**Project: PSD: Kamiak Elementary School****Date: November 15, 2018****Weather conditions:**

Discussion with: No Construction Progress Meeting today 11/15/18. I toured the project with Ned Warnick, Derek Oliver, Joe Thornton and Evan Hecker.

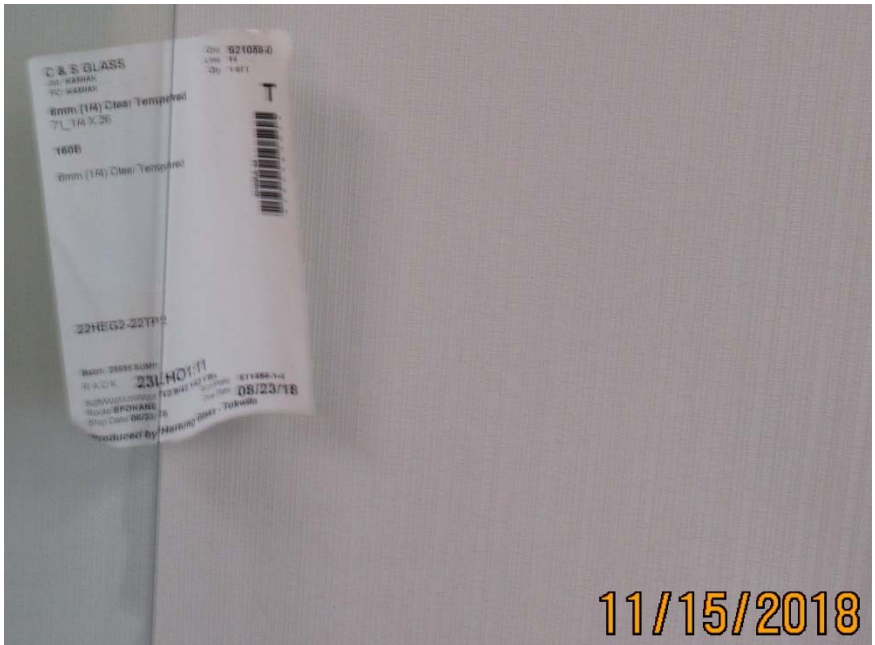
- 10. It appears the contractor is installing glazing in the interior classroom windows. The glass is loose in the frame. See below.**

- 11. It appears the contractor is installing 1/4" tempered glass. This is incorrect because this was changed to laminated safety glass (two layers of 3/16" thick clear float glass, laminated with 0.060" thick poly vinyl butyl interlayer) with the acceptance of PR-25 on 8/23/18.**
